METROPOLITAN GOVERNMENT OF NASHVILLE AND DAVIDSON COUNTY

STAFF RECOMMENDATION
1608 16th Avenue South
April 19, 2017

Application: New construction – addition; Setback determination
District: South Music Row Neighborhood Conservation Zoning Overlay
Council District: 19
Map and Parcel Number: 10408035000
Applicant: Chris Gill
Project Lead: Sean Alexander, sean.alexander@nashville.gov

1 SOUTH ELEVATION
 1/8" = 1'-0"

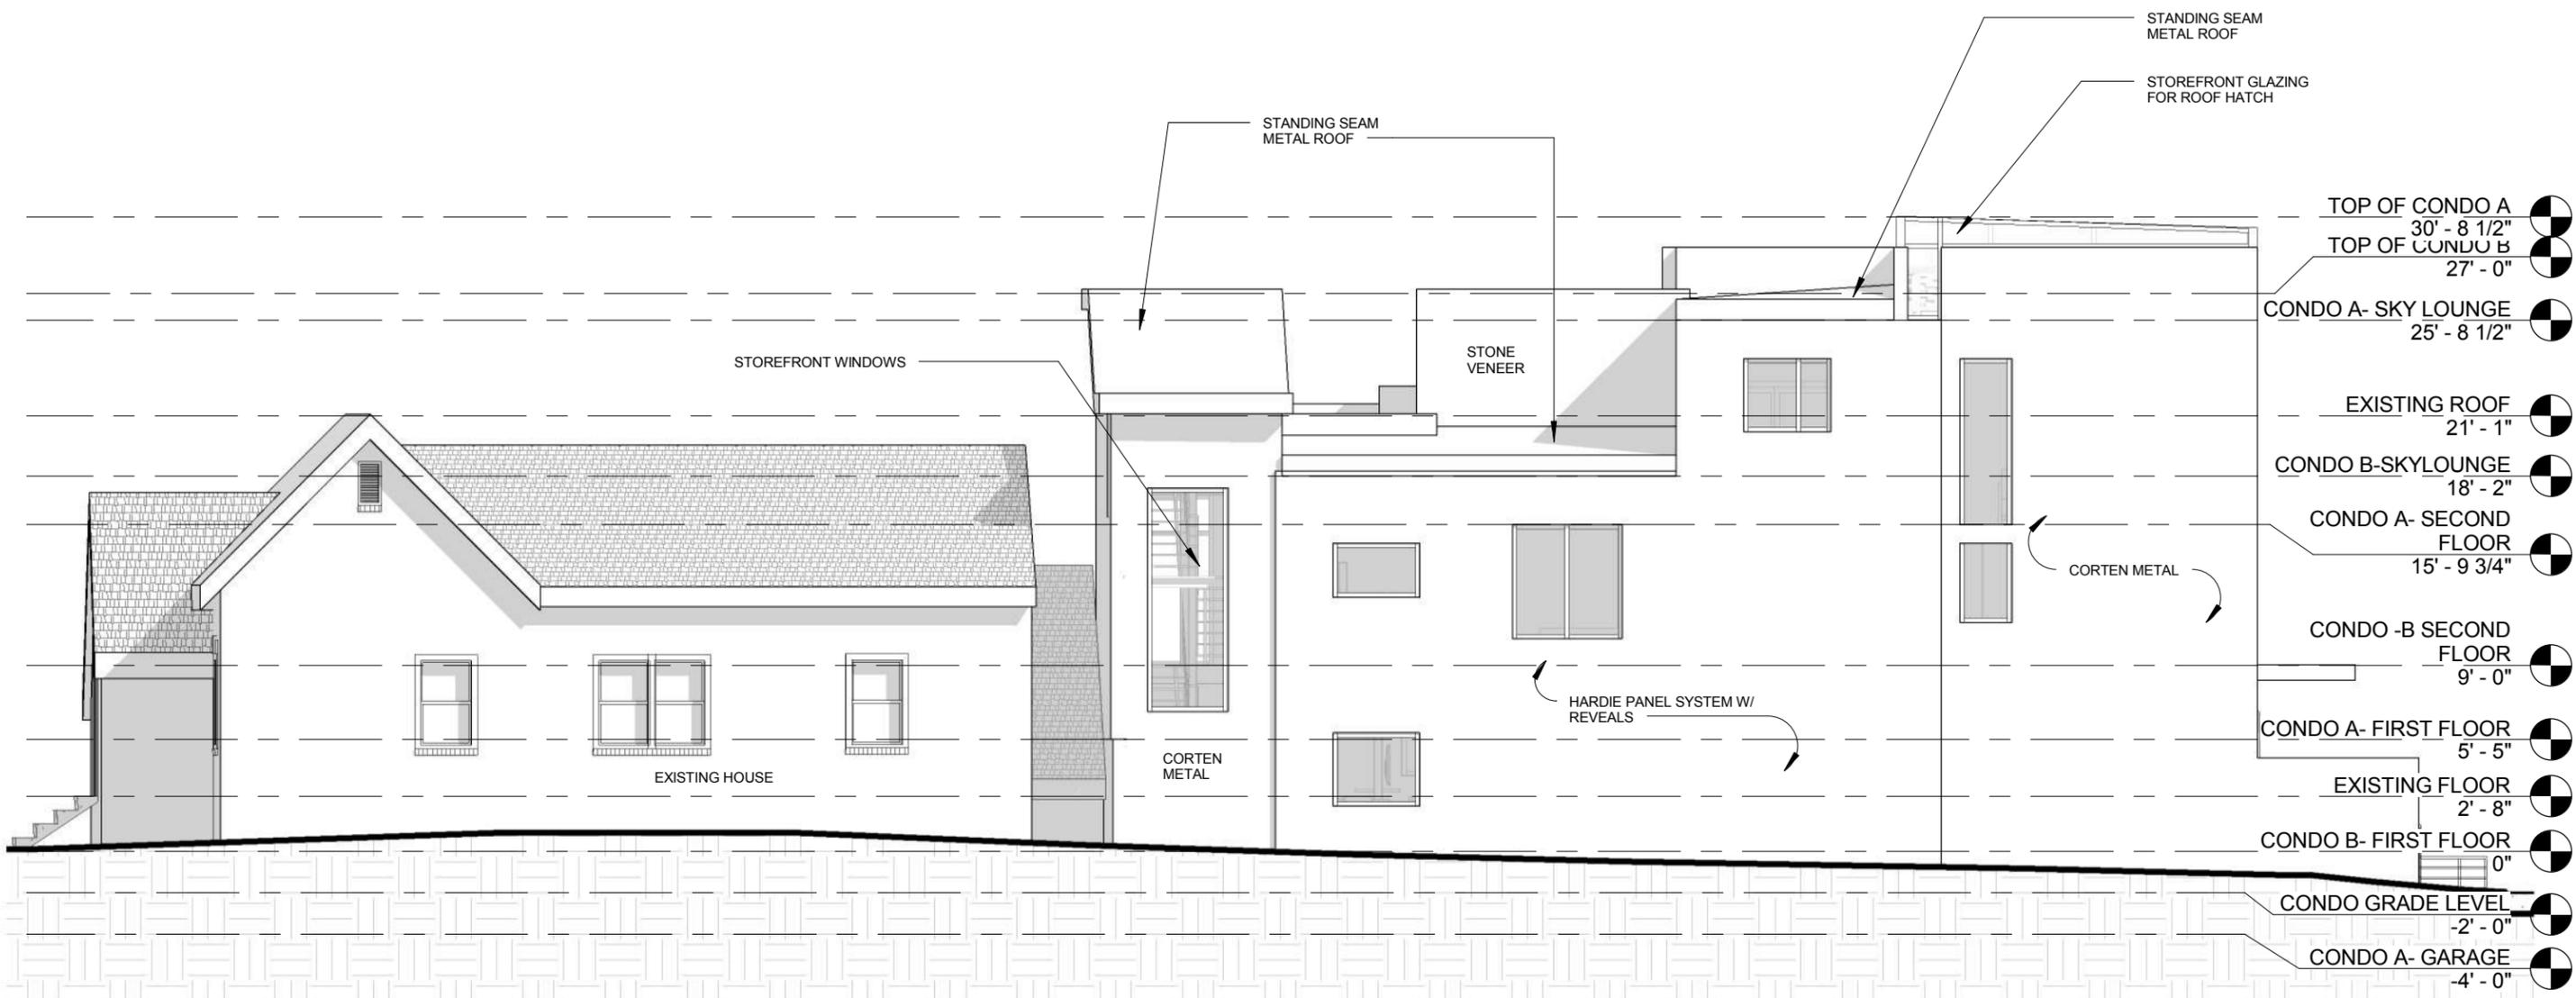
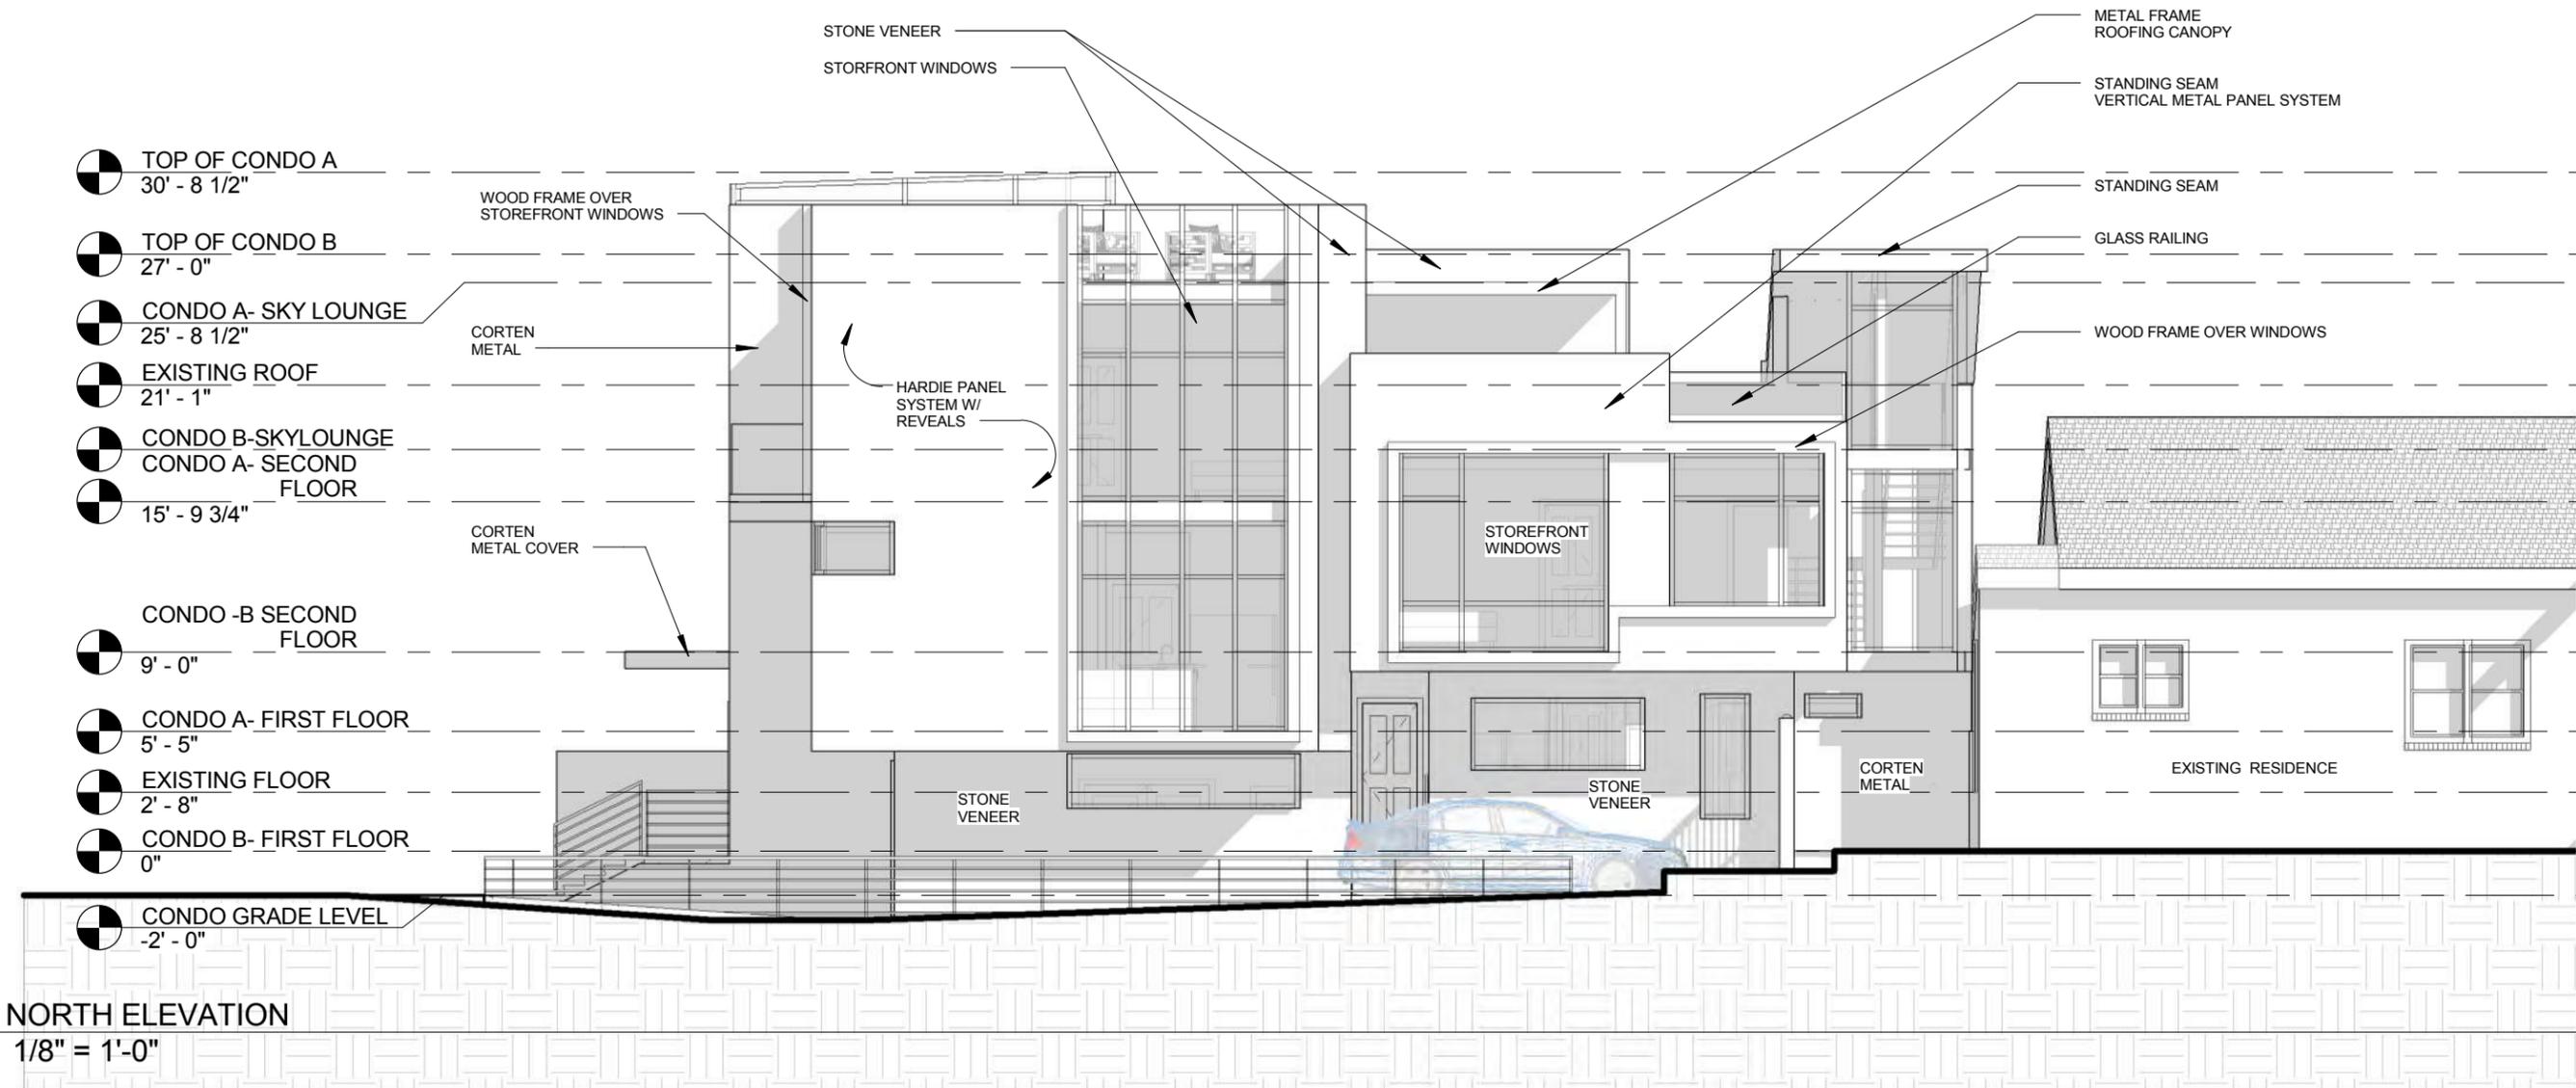
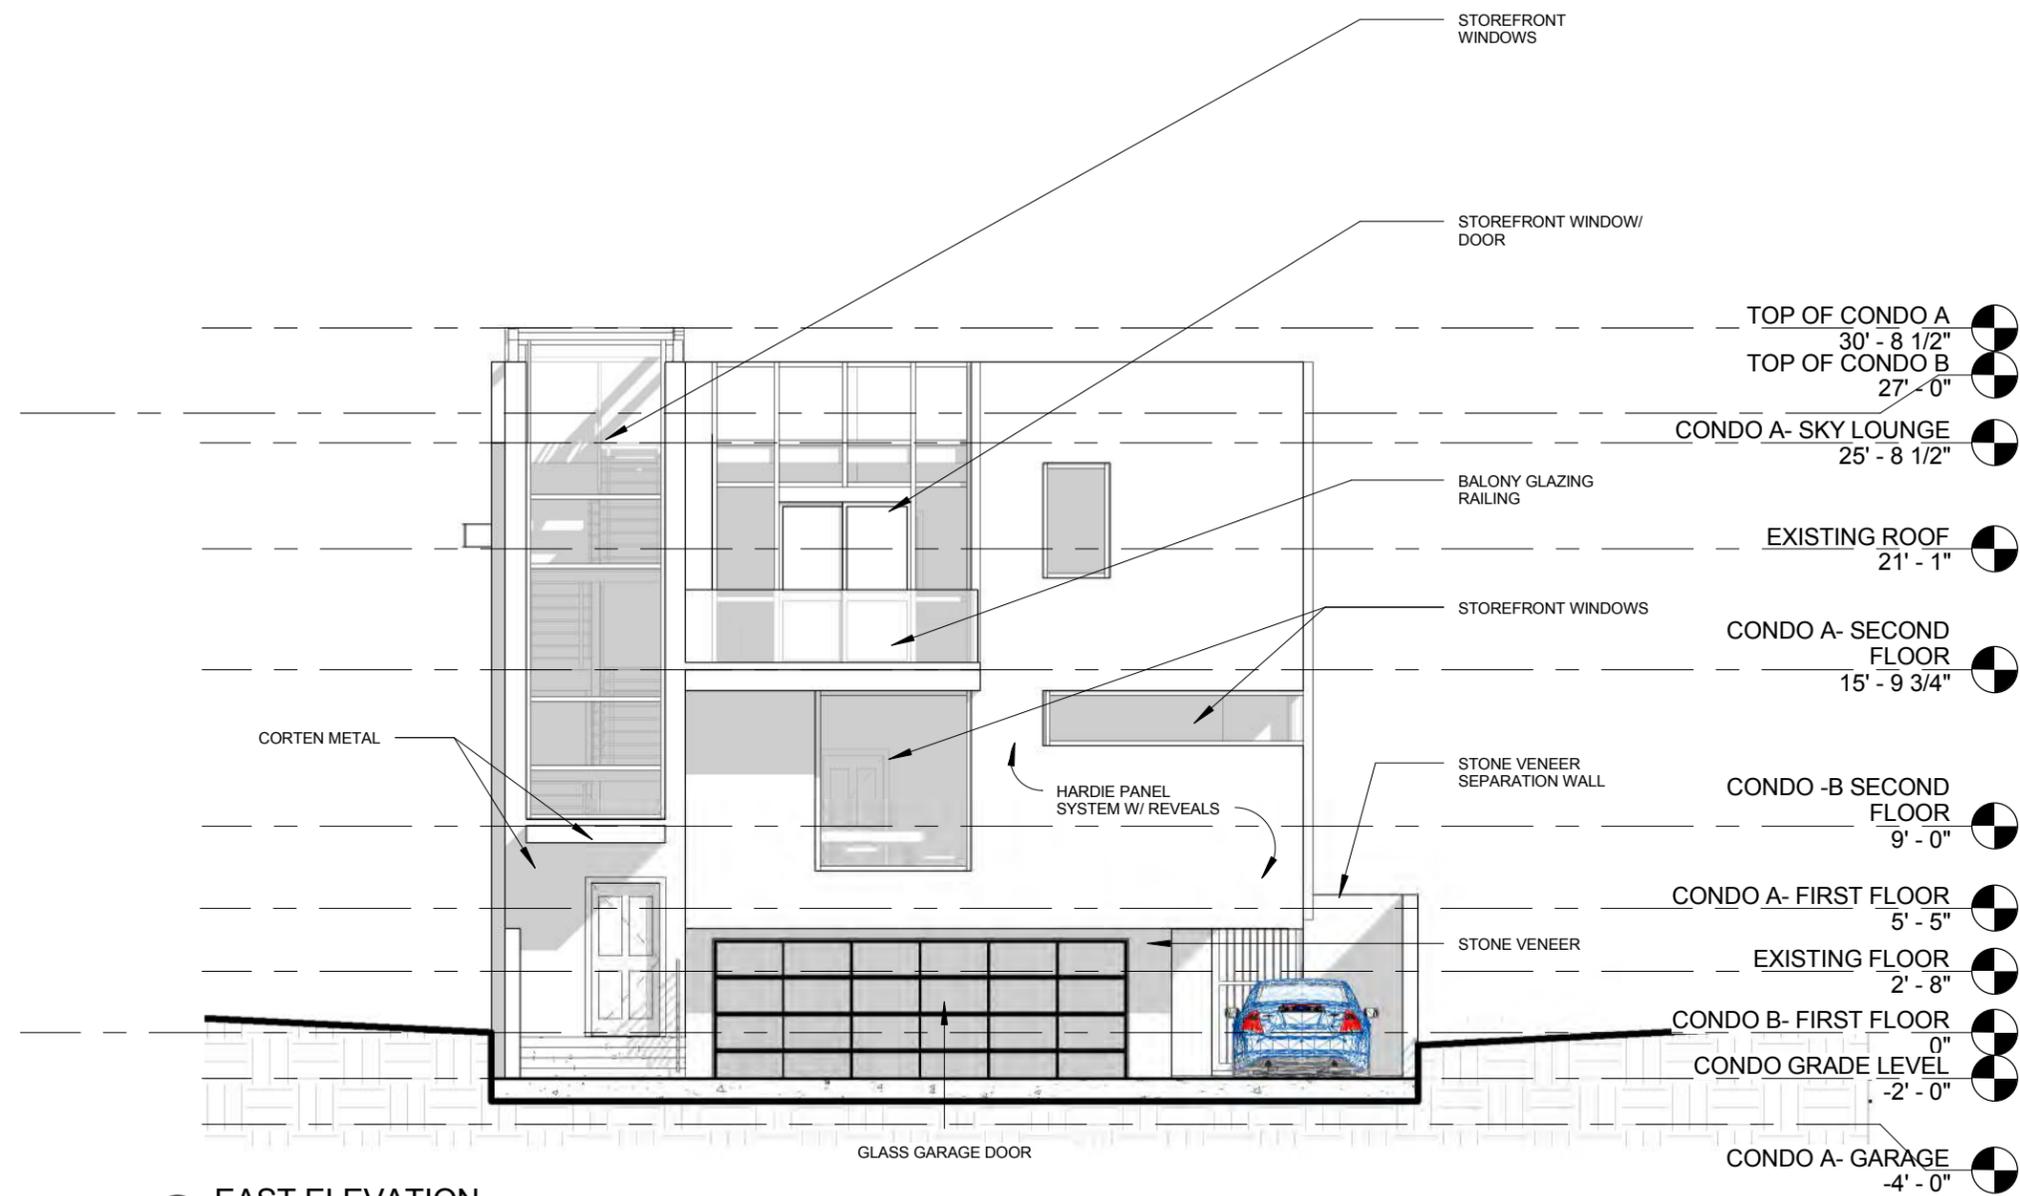
Height, Scale & Building Shape: The addition will have a split-level shape, with two levels in the front unit and two and a half in the rear, with roof decks on both units. The roof of the front unit will be two feet (2') lower than the roof of the house and the roof of the rear unit will be four feet, six inches (4'-6") taller. The taller roof section begins seventy-seven feet (77') back from the front of the building. In addition to the taller roofs the addition will have a stair tower and a railing on the roof deck that extend to six feet (6') and eight feet (8') taller than the original roof, respectively. Additions more than four feet (4') taller than an historic house are generally not considered appropriate; however, in this case Staff finds the proposal to be appropriate because the impact on the

Design: The character of the addition is contemporary and would not be mistaken for an original part of the building. The addition's primary roofs will be flat, and the proportions of windows will be larger and more square than those of the historic houses. Although the form of the addition is not typical of nearby historic buildings, Staff finds the addition to be appropriate given the minimal physical impact it will have on the historic building, and its location at the rear of the lot approximately ninety feet (90') to one hundred, thirty feet (130') from the street. For these reasons, and because of the

Roof form: The addition will have tiered sections rising to the rear, with the majority of the sections having flat roofs. Although flat roofs are not typical of historic buildings in the area, Staff finds the addition to be appropriate given the minimal physical impact it will have on the historic building, and its location at the rear of the lot approximately ninety feet (90') to one hundred, thirty feet (130') from the street. In addition, the district has several low-sloped hipped roofs that from the street, can take on a flat-roof appearance. For these reasons, and because of the unique historical character of the South Music Row district, Staff finds the project to be appropriate and to meet section II.B.1.d of the design guidelines.

Proportion and Rhythm of Openings: The windows on the proposed addition do not have the proportions and patterns typical of historic buildings nearby, particularly on the left side where windows comprise roughly half of the wall space. The windows on the right side are more like that of historic windows in their placement, but the sizes are also not typical of historic houses. No changes to the window and door openings on the existing house are planned.

Recommendation: Staff recommends approval of the proposed addition to the contributing building at 1608 16th Avenue South with the condition that the stone, metal, concrete, and window and door selections are approved by MHZC Staff prior to purchase and installation. Given the unique historical character of the area, Staff finds the project would be appropriate and meet the design guidelines for the South Music Row Neighborhood Conservation Zoning Overlay.
